**APPLICATION  
FOR PERCOLATION TESTING AND SITE EVALUATION**

**From:** Silvast, Zackary  
**Sent:** Monday, January 31, 2022 11:42 AM  
**To:** frank.white@kci.com  
**Cc:** Askariza79@gmail.com; Williams, Jeffrey  
**Subject:** OSDS comments for 14945 Old Frederick Road (EH-PLANS-22-0011)  
**Attachments:** 14945 updated specs.pdf; 14945 perc cert 1.pdf; 14945 perc cert 2.pdf

**From:** Silvast, Zackary  
**Sent:** Tuesday, November 29, 2022 4:42 PM  
**To:** 'Frank White'  
**Cc:** Williams, Jeffrey; 'Jacob Leimbach'  
**Subject:** regarding 14945 Old Frederick Road PC & OSDS plans (BP# - B22001367)

**LOT 5, RIZVI PROPERTY**  
**ON-SITE SEWAGE DISPOSAL SYSTEM DESIGN PLAN**  
14945 OLD FREDERICK ROAD  
WOODBINE, MD 21797  
TAX#: 348885, SUB: 1001

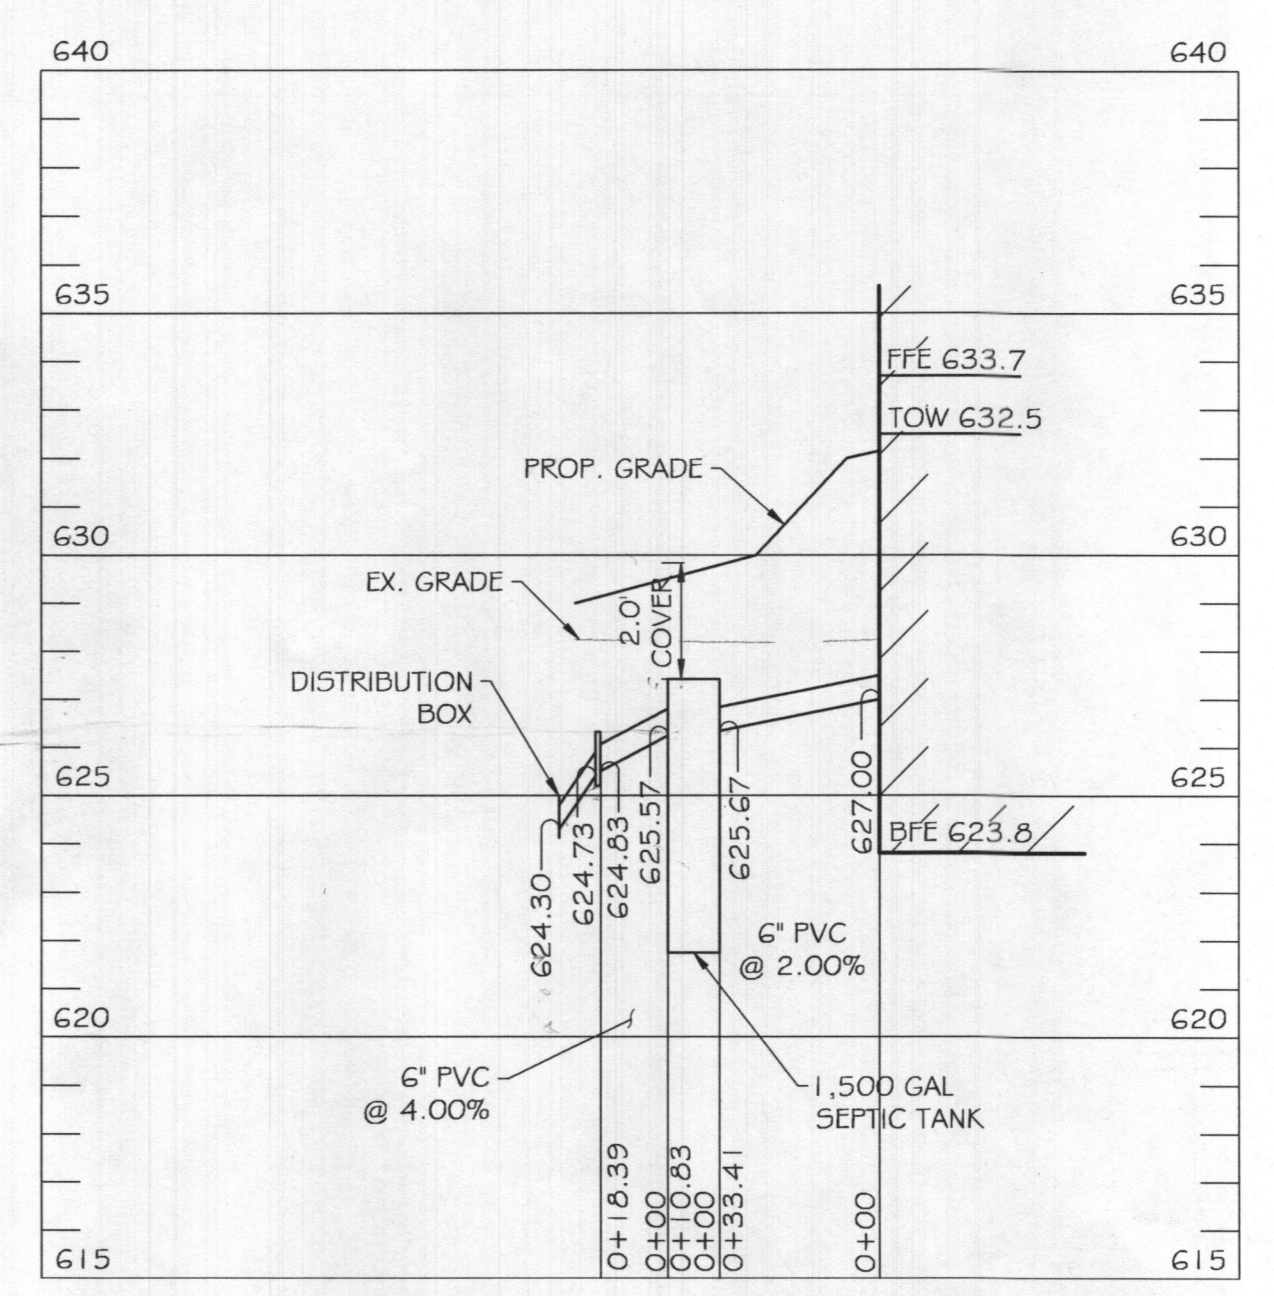
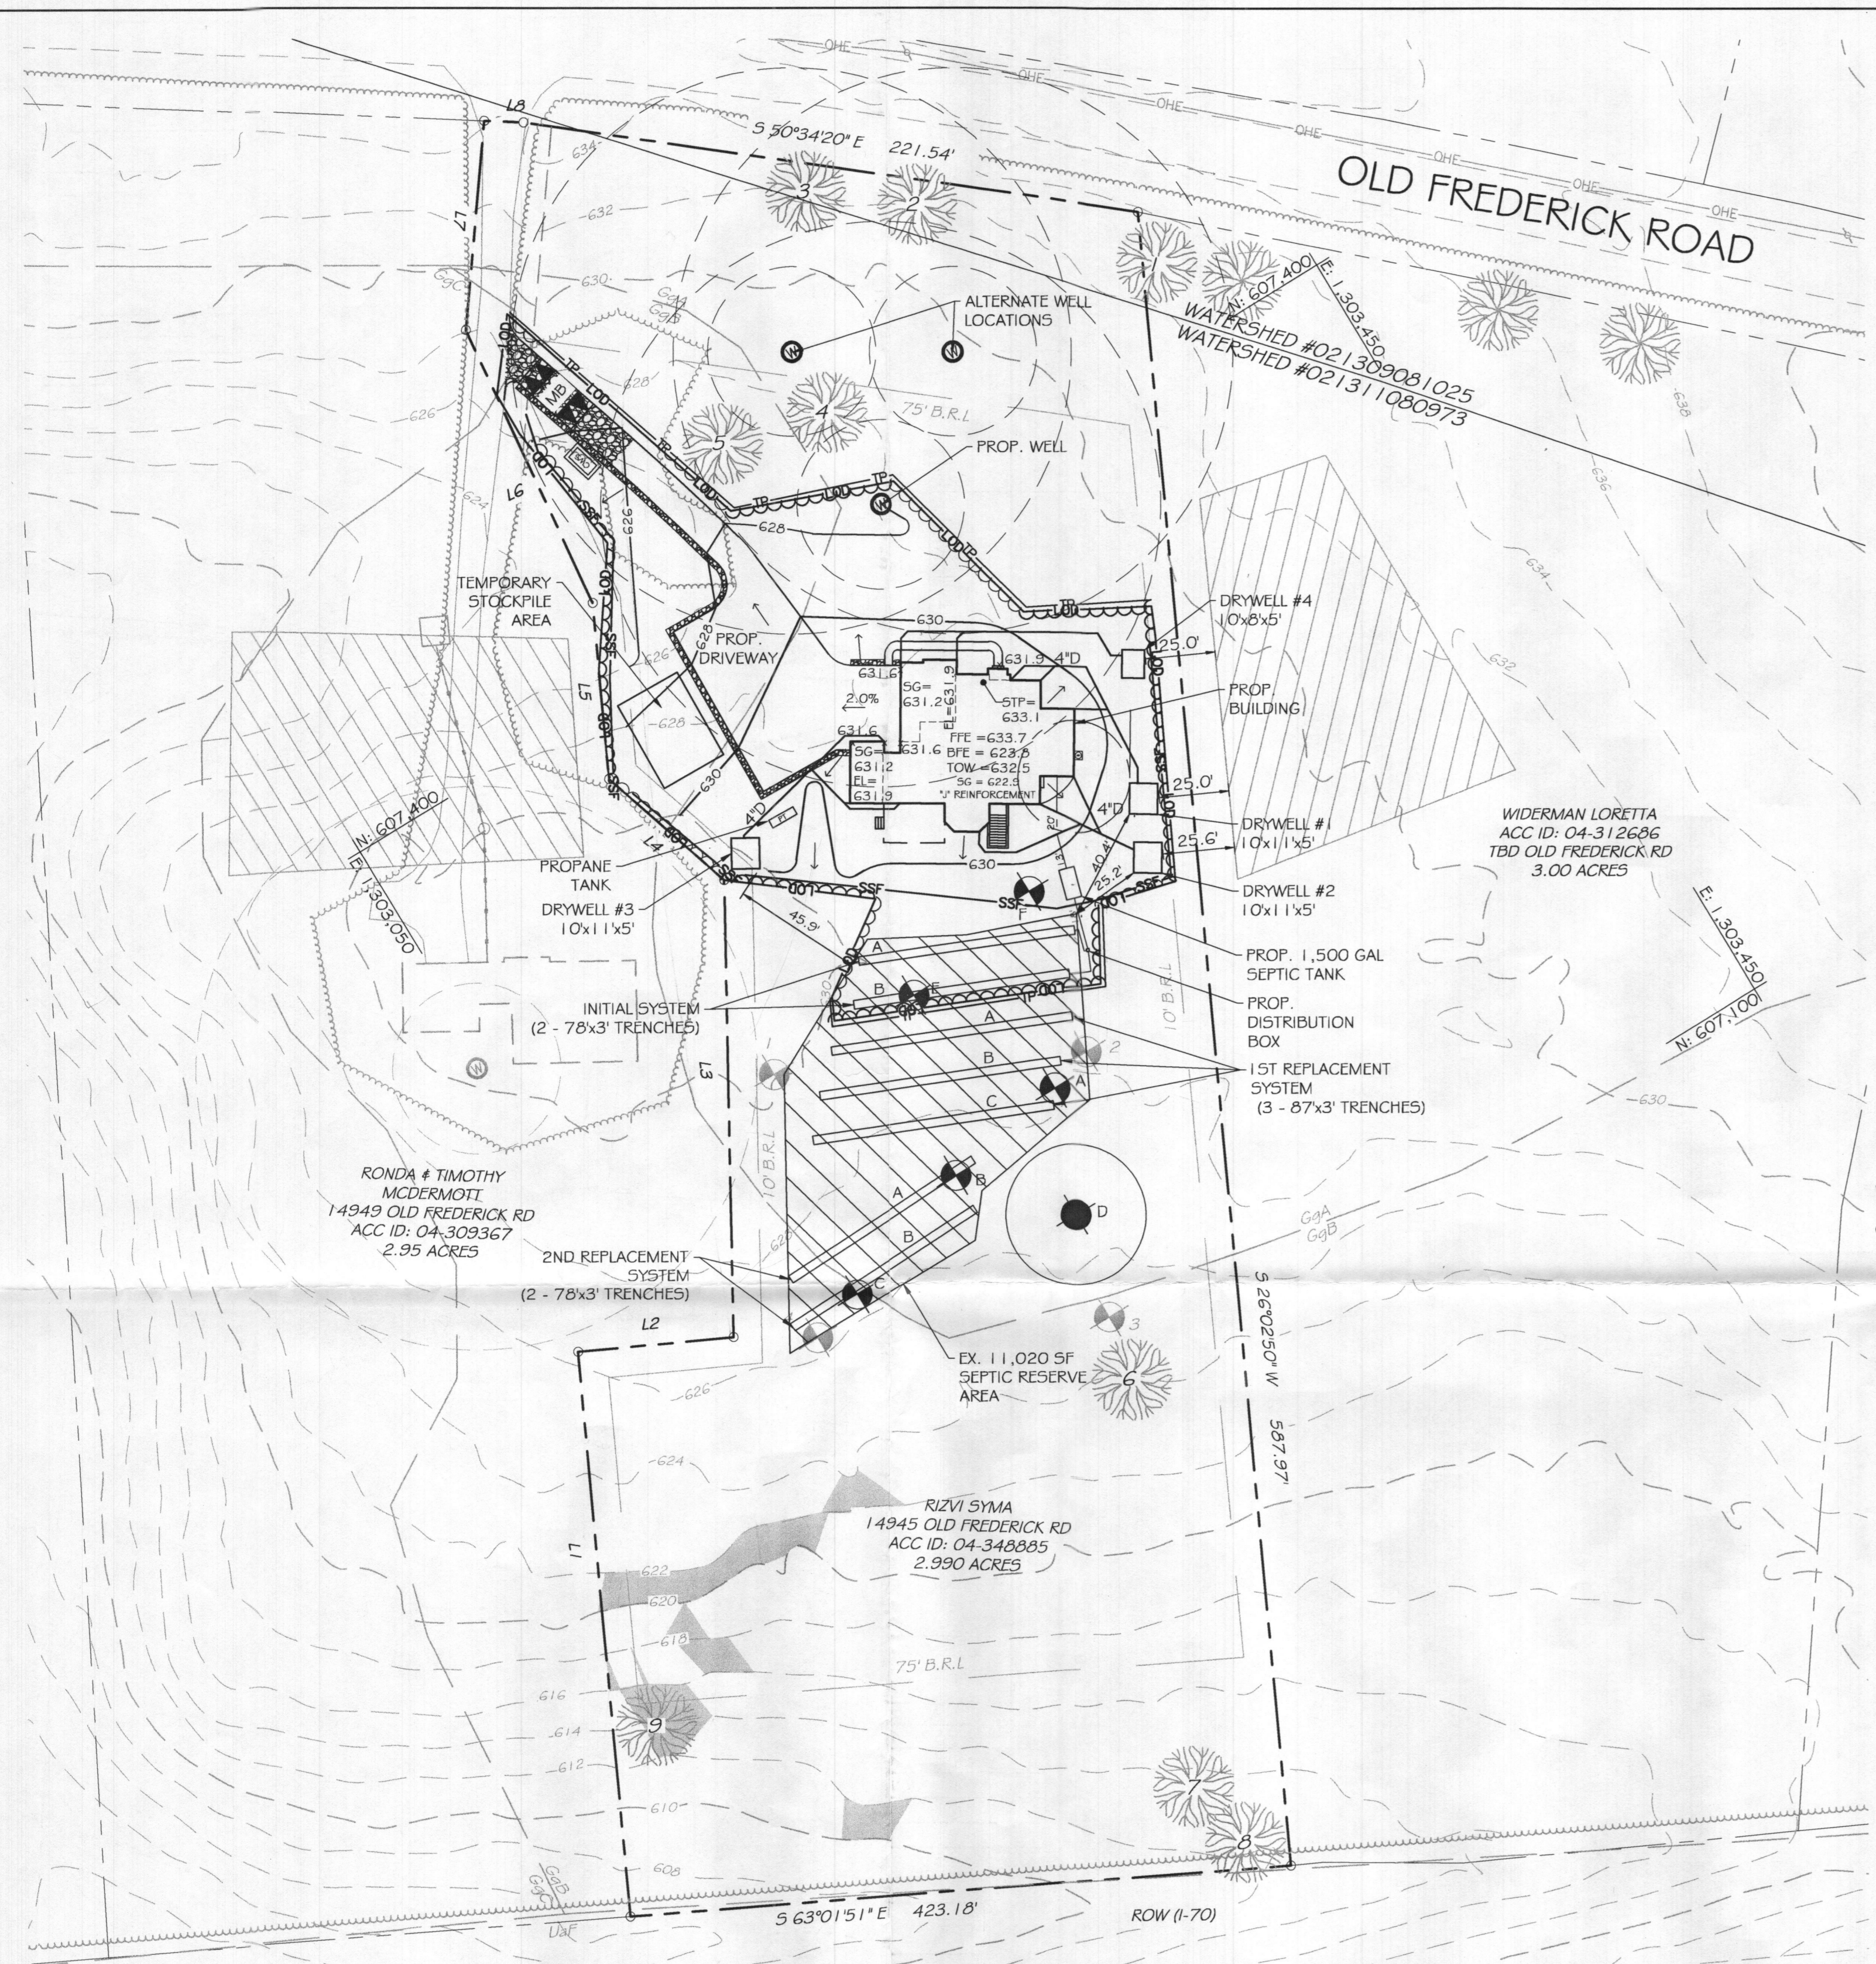
1. **The building permit (B22001367) submitted in April, shows floor plans for a 5 bedroom house with an unfinished basement.**
  - a. **The septic system design on this OSDS plan is for a four bedroom house so it is not currently adequate. (should at least be a 750 GPD maybe even a 900 GPD design)**

2. **Comment #1 beings me to a larger request which is to not take contour line "630" so literal on the trench layout.**
  - a. **I believe the first two trenches of the initial septic system should span straighter and across the top of the SDA. (still slightly angled as to match the other contours)**

3. **Another example of adjusting trench layout, straighten out the bottom two trenches of the 2<sup>nd</sup> replacement system and have them run across the very bottom of the SDA.**

4. **The trenches for 1<sup>st</sup> replacement system should be linear and parallel with each other.**
  - a. **The trenches A & B are 30' apart initially and 15' apart at the end. (too much)**

5. **The septic tank should ideally not encroach the SDA, there is no need for it on this lot.**
  - a. **I think the tank orientation goes against the drainfield orientation. (tank should be angled or perpendicular)**

6. **There should not be two 45 degree bends so close to each other in the septic line from the house to the septic tank.**
  - a. **You could come straight out of the house and put in one 45 degree bend to the tank where applicable.**

7. **No part of a trench should be above the septic tank in a gravity system.**
  - a. **Referencing the awkward septic layout of the initial system.**

**EX. SEPTIC SYSTEM PROFILE**  
SCALE: H. 1" = 4'  
V. 1" = 4'

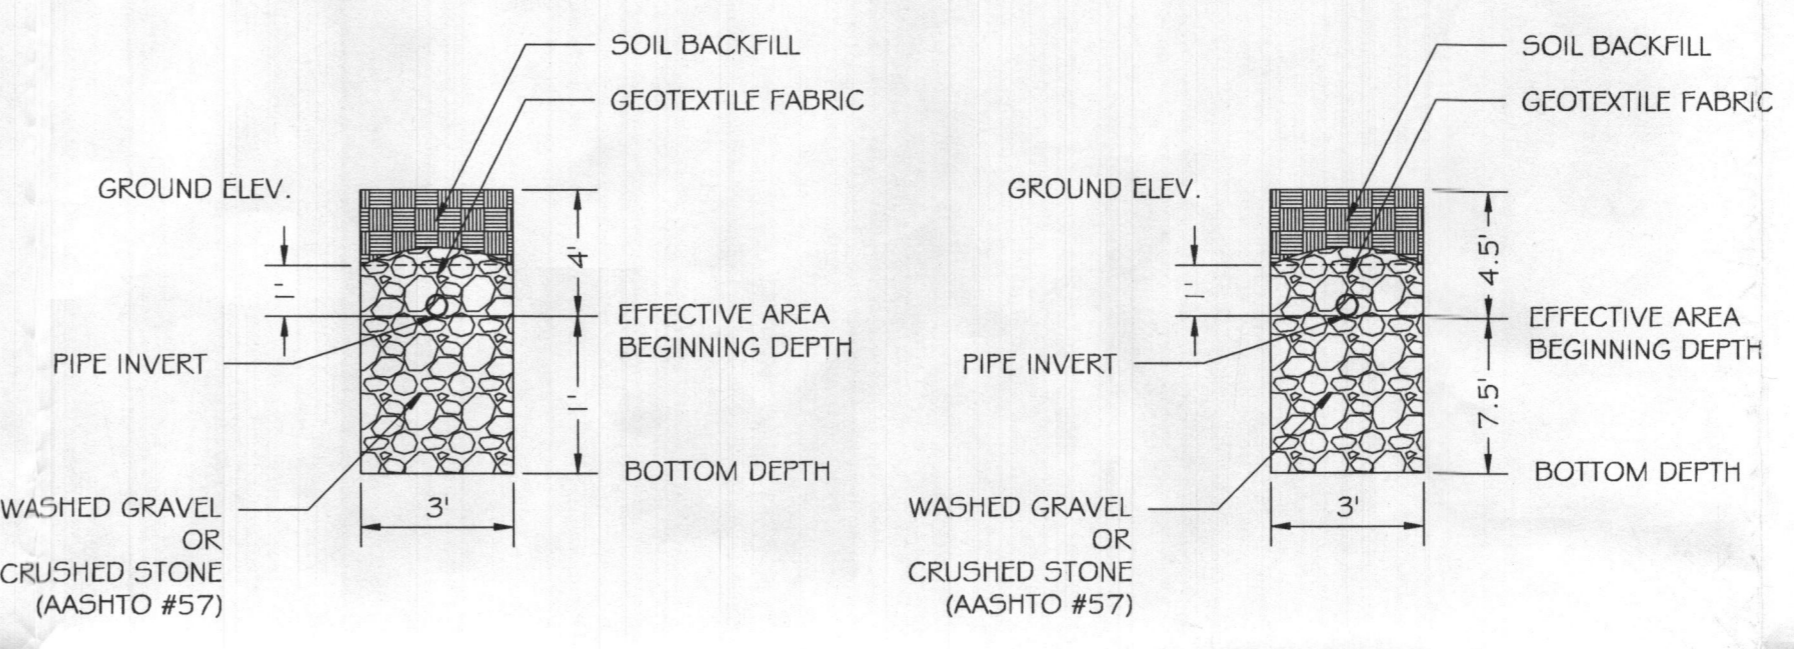
New d-box elev

- new invert depth 4' or less
- change depth or trench details
- all elev. in profile are off
